NOTICE TO ALL FIRMS

Date: January 28, 2025
To: All Prospective Bidders
From: Sam Li
Director of Procurement Services
Re: Addendum Number 4
IFB # C1667 – Dubinsky & Business and Liberal Arts Lobby Renovation

- 1) Addendum #4 for bid C1667 provides updates Fire Alarm drawings (E300.00, E301.00, & E311.00), revised lighting control notes (E701.00). Additionally Phase II demolition (ED111.00 & ED112.00) is coordinated with the work shown on the fire alarm sheets. Lastly, as requested, Phase II lighting plans (EL111A.00 & EL111B.00) call out the missing room name.
- 2) **The bid due date for this project is now February 7, 2025, 12:00 PM. We must receive the bids on or before February 7, 2025, 12:00 PM**
- 3) The tentative award date is Feb. 21st.

57-24140-02
FIRE ALARM
PLANS - PHASE II

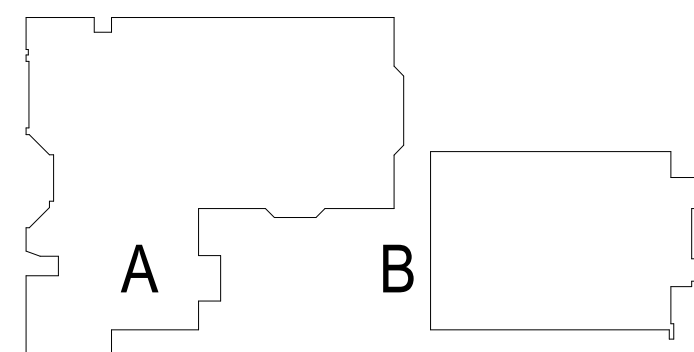
- Q1. Extending this 4 business days is difficult for the lighting and Fire Alarm vendors. Requesting a bid extension.
- A1. Bid due date extended from Monday February 3rd, 2025 to Friday February 7th, 2025. We do not expect to extend the bid due date any further.
- Q2. E311.00 is missing. This completes the Fire Alarm request I have forwarded to the vendor.
- A2. See E.311.00 in Addendum #4 for the missing sheet.
- Q3. The controls remain a question as the narrative describes the replacement of the lighting control system and the plans call to connect to the existing system. Lighting Rep is confused.
- A3. See E701.00 in Addendum #4 for more information.

1 EXISTING FIRE ALARM CONTROL PANEL. UTILIZE EXISTING LOW VOLTAGE CONDUCTOR PATHWAYS TO ROUTE NEW FIRE ALARM HOMERUNS ORIGINATING FROM NEW TURNSTILES TO PANEL FROM CEILING OF FLOOR BELOW.
